<b>DART AEROSPACE LTD</b>	<b>Work Order:</b> 77305
<b>Description:</b> Crosstube Assembly (412 High Aft)	<b>Part Number:</b> D412-664-243
<b>Inspection Dwg:</b> D412-664-243 <b>Rev:</b> E	<b>Page 1 of 1</b>

DRAWING NO. D412-664-243	TITLE CROSSTUBE ASSEMBLY (412 HI AFT)	REV. E	DART AEROSPACE LTD ENGINEERING ORDER		D.E.O. NO. D412-664-243-E-1	SHEET NO. SHEET 1 OF 2	SCALE NTS
DRAWN	CHECKED	MFG. APPR.	APPROVED	DE APPR.			
DATE 11.03.31	DATE 11/03.31	DATE 11.03.31	DATE 11/03.31	DATE 11.03.31

DRAWING NO. D412-664-243	TITLE CROSSTUBE ASSEMBLY (412 HI AFT)	REV. E	DART AEROSPACE LTD ENGINEERING ORDER	D.E.O. NO. D412-664-243-E-1	SHEET NO. SHEET 2 OF 2	SCALE NTS
DRAWN	CHECKED	MFG. APPR.	APPROVED	DE APPR.		
DATE 11.03.31	DATE 11.03.31	DATE 11.03.31	DATE 11.03.31	DATE 11.03.31

DRAWING NO. D412-664-243	TITLE CROSSTUBE ASS'Y (412 HI AFT)	REV. E	DART AEROSPACE LTD ENGINEERING ORDER		D.E.O. NO. D412-664-243-E-2	SHEET NO. SHEET 1 OF 1	SCALE NTS
DRAWN <i>qp</i>	CHECKED <i>ASS</i>	MFG. APPR. <i>RE</i>	APPROVED <i>WP</i>		DE APPR. <i>#</i>		
DATE 11.09.07	DATE 11.09.19	DATE 11.09.19	DATE 11.09.19		DATE 11.09.19

**D412-664-243  
ASSEMBLY DETAIL**

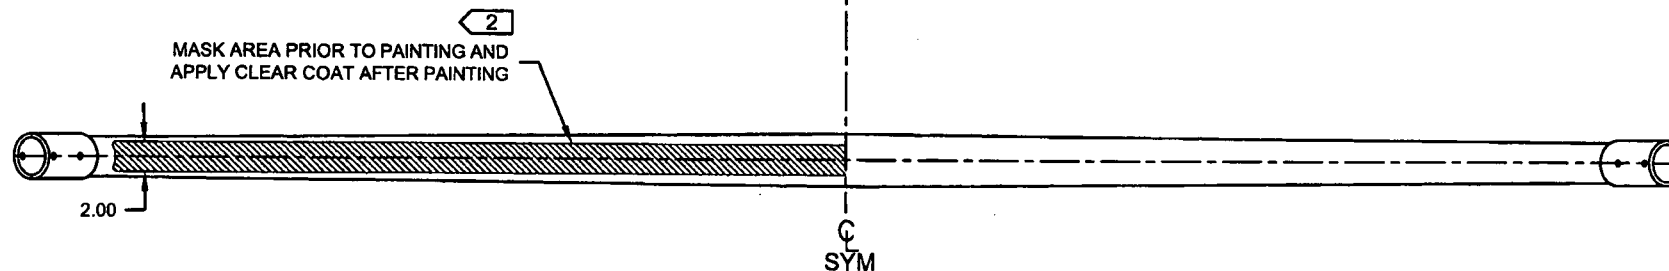
**PURPOSE:**

REMOVED ABRASION STRIP IN FAVOR OF A THIN LAYER OF PROSEAL 890.

**IS:**

D3189-1 CHAFING SHIELD (1, INSTALLED OVER PROSEAL 890)  
MS21920-28 CLAMP, 2X  
2 PL

**WAS:**

D2856-600-1009 ABRASION STRIP  
D3189-1 CHAFING SHIELD (1, INSTALLED OVER ABRASION STRIP)  
MS21920-28 CLAMP, 2X  
2 PL
